# Product Change Notification

<b>Date Issued :</b>	November 11, 2022	<b>PCN Number :</b>	512997
<b>Reason for Change :</b>	Change Supplier		
<b>Description of Change :</b>	Supplier Change : this notification is to inform you about a change of resin suppliers impacting the part(s) attached as per list. No changes will be made to product as part of this change.		
<b>Reason for Short Notice :</b>	Special Request		
<b>Assessment of Change :</b>	Reliability Test Report/s		
<b>Planned Implementation Date :</b>	February 01, 2023		
<b>Sample Availability Date:</b>	November 09, 2022		
<b>Internal Molex Qualification Date :</b>	November 09, 2022		
<b>Last date to request Samples by Customer :</b>	January 18, 2023		
<b>Traceability Code Markings / Date :</b>	Lot information on label

## Change Overview

**Change Overview**

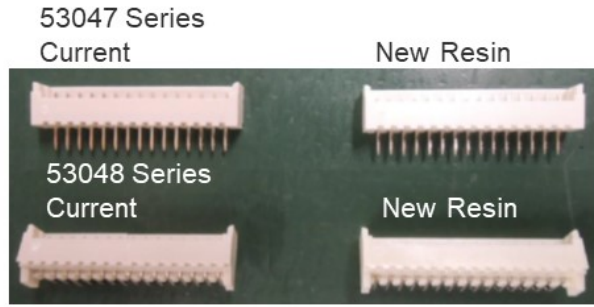
➤ Color difference

After changing the resin, the color will be slightly brighter.
